CITY OF WEST TORRENS

Notice of Panel Meeting

6.1.1 11 Shaw Avenue, RICHMOND

Application No 211/349/2021

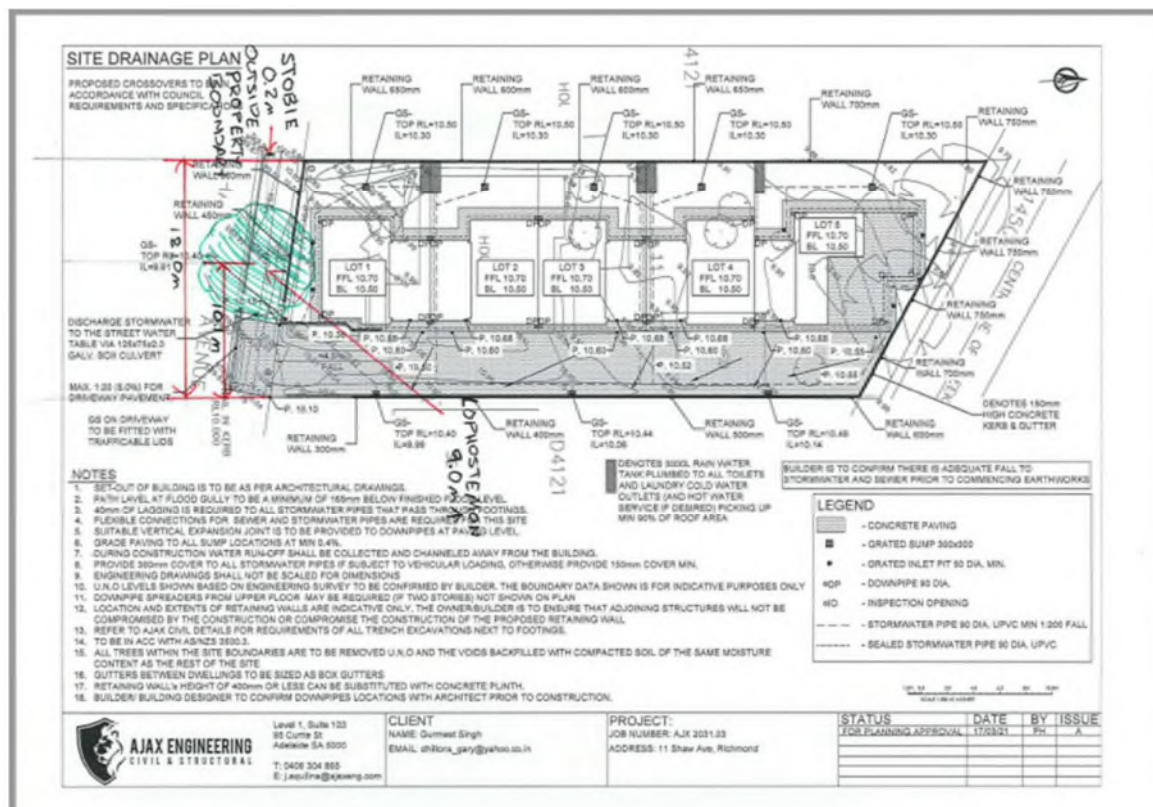
A site investigation together with the information provided has revealed that for the proposed development at 11 Shaw Street Richmond, City Operations in this instance will support the proposed crossover.

However the proposed stormwater outlet will be required to maintain a minimum distance of 2.0m west of the existent Lophostemon street tree located 10.1m from the Eastern boundary

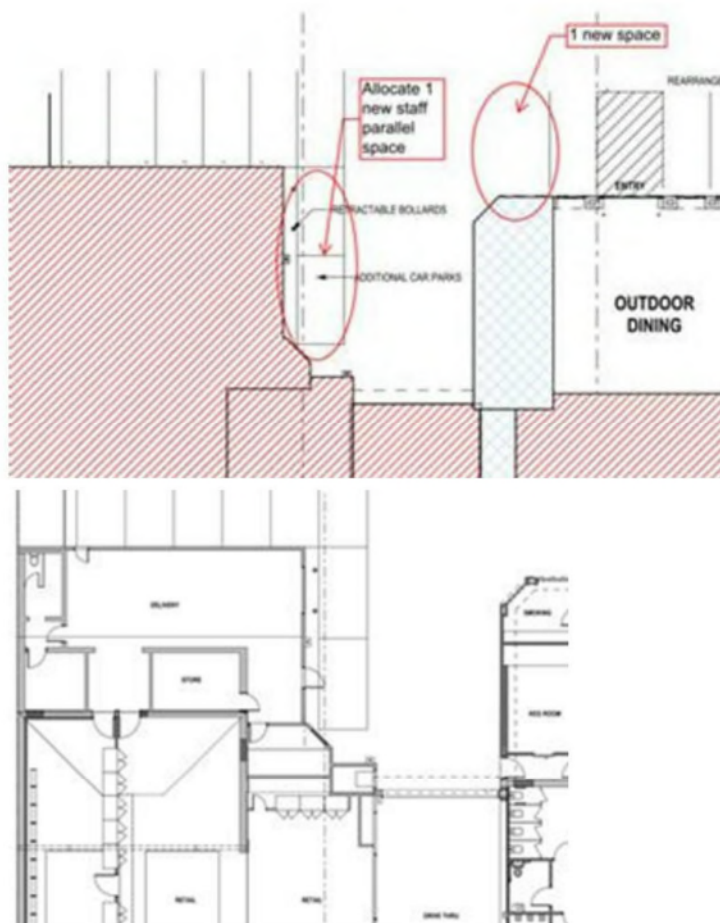
From my review of the current and proposed car park layout, it would seem to me that there would be opportunity to increase on-site parking by 2 spaces (see circled areas below):

- The expansion of the retail shop seems to be associated with the current drive-through liquor store based on the indicative floor layout plan. At the northern end of the retail shop, there is a delivery area which seems to have a roller shutter door leading out to the drive-through roadway. I

would anticipate that deliveries to the store and storage area of the retail shop would primarily occur via this roller shutter door. It would therefore be desirable that the roller shutter door remain unobstructed. Two parallel spaces would not be possible as proposed by the Applicant adjacent to the retail shop. One parallel space would be possible and should be allocated as STAFF parking.

- The second new space could be provided by extending the parking row adjacent to the Outdoor Dining area.

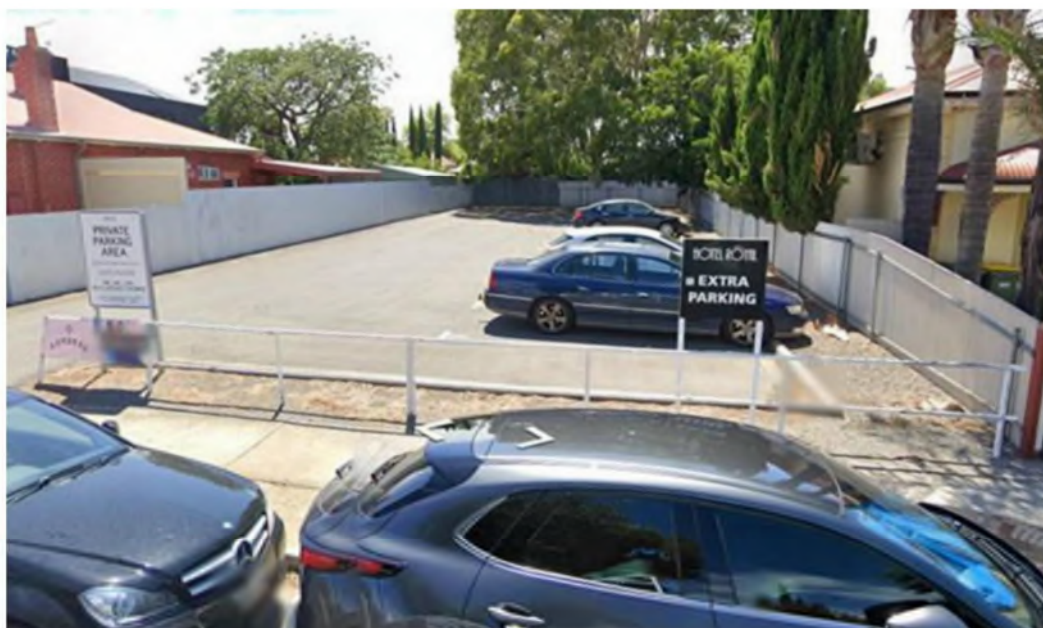
- 1.3.1** There is an existing car park at 6 Jervois Street that is 'linked' to the subject hotel. This site is not reflected in the overall Site Plan. I leave it to the Council planner to comment on whether the car park at 6 Jervois Street should be formally 'linked' to the hotel development and shown on the Site Plan to include this existing hotel car park at 6 Jervois Street.

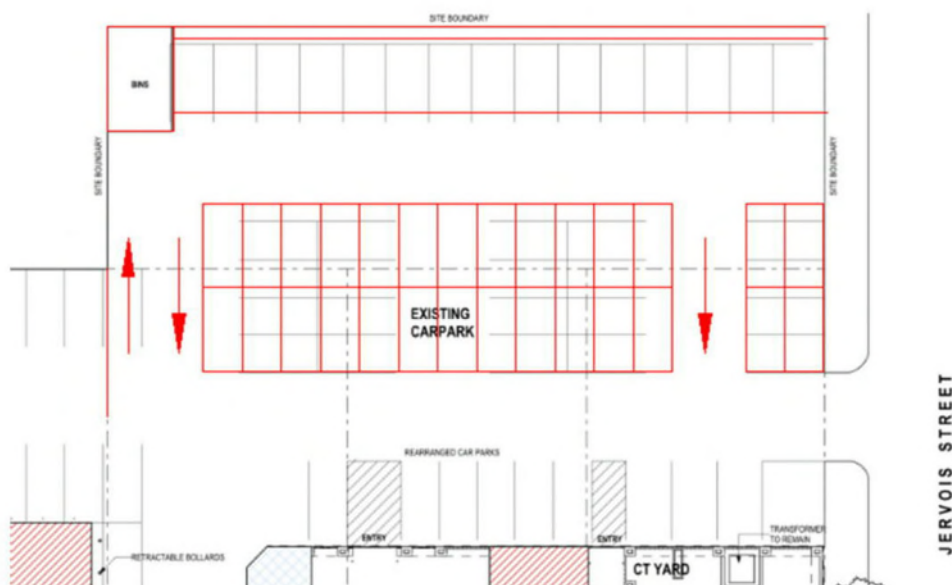
1.3.2 While it may not be directly relevant to the application, from my review of the existing parking layout, it would seem that there may be an opportunity to increase the parking on-site by adjusting the parking dimensions and making some alterations to the northern parking row (if feasible). There is an existing planting hedge along the northern row. In the absence of a detailed survey plan, if the existing hedge could be trimmed back and cars allowed to overhang 0.6m onto the landscape strip, it may be possible to amend the parking layout to that shown below. This amended layout would be significantly more efficient and could accommodate say 6 to 8 new spaces. However, this would depend on the actual dimension that would be available between the hotel building and the northern boundary. Given the parking situation for the existing hotel, I recommend that this option, which would be of benefit to the hotel, be investigated further by the Applicant.

- 1.3.3** The existing waste area at the north-western corner of the site is retained. However, there is no commentary provided about the other servicing aspects of the hotel or the retail shop.
